Corrigendum to EN 60439-3:1991

Annex ZA

A-deviations

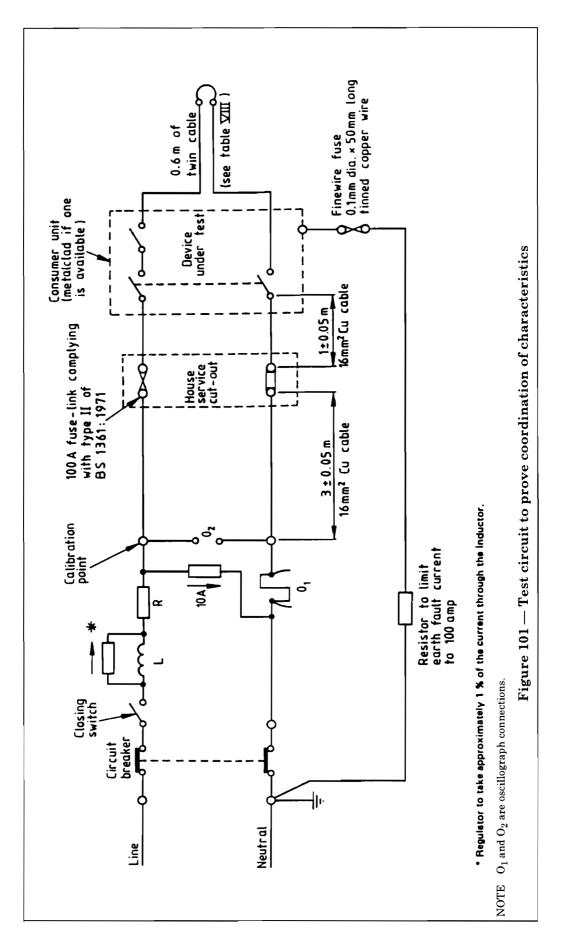
- d) The test circuit shall be connected as shown in Figure 101. The relative positions of the closing switch, inductive reactor and resistor are not obligatory, but the resistor shall be in series with the master circuit-breaker.

The value of the prospective short-circuit current shall be $16 \text{ kA} \pm 0\%$ at a power factor of 0.6 ± 0.05 determined from a calibration oscillogram taken with a link of negligible impedance positioned as shown in Figure 101. All parts of the equipment normally earthed in service, including its enclosure, shall be insulated from earth, but shall be connected to the neutral of the supply or to a substantially inductive artificial neutral, permitting a prospective fault current of at least 100 A.
